GFELLER LINE CONCENTRATORS  
49-9-2, 49-11+1-2, 49-12-2  
AUXILIARY AND APPLIQUE CIRCUITS  
DC OPERATION

1.01 This appendix is issued to include the the necessary information on units converted to DC battery operation.

Fig. 2A

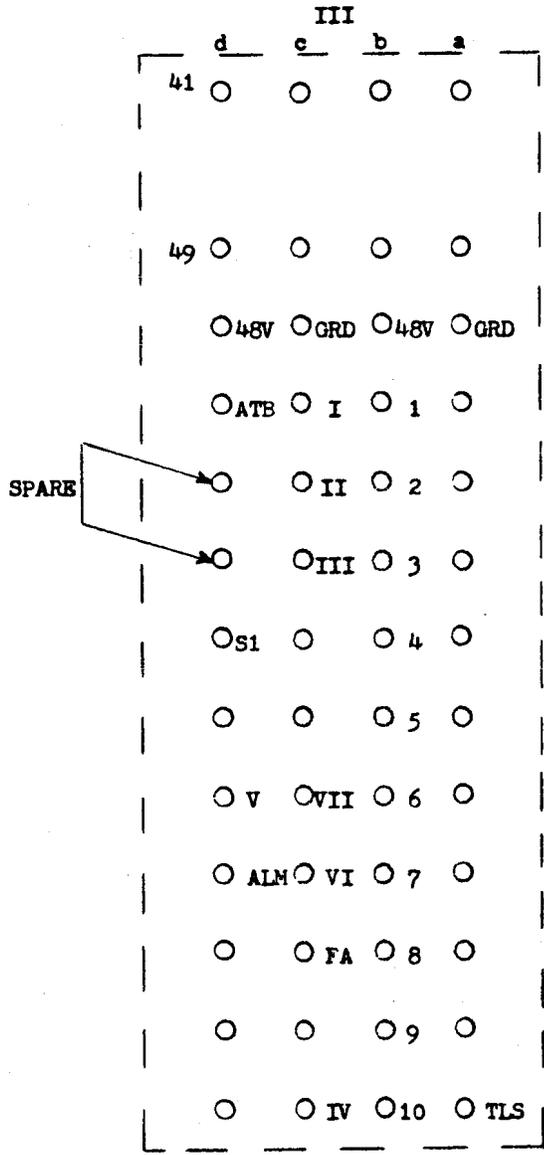
Fig. 2A replaces Fig. 2 on page 4 of the section. It shows the arrangement of terminal strip III on low serial number Gfeller units that have been modified for plus-and-minus battery operation. Table A gives obsolete information and should be disregarded.
